### Galway City Council Proposed Bus Connects Galway Dublin Road and Cross-City Link (University Road to Dublin Road)

#### GCCN Submission

January 2021

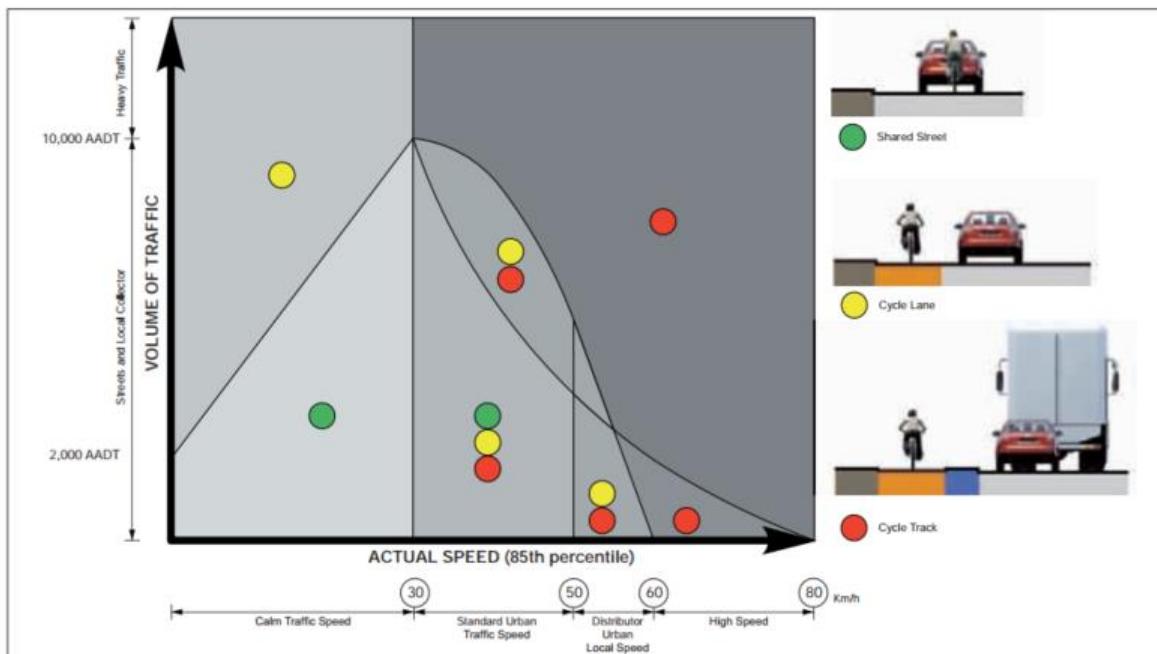
The scheme is based on shared space between cyclists and other road users. Between 7am and 7pm this includes buses, taxis and local traffic. Outside of these hours it would include other car traffic. There are concerns that this is unsuitable for cyclist safety. Have projections for traffic on these roads been developed to show that this mixing is suitable? Please see the Guidance Graph from the National Cycle Manual<sup>3</sup>:
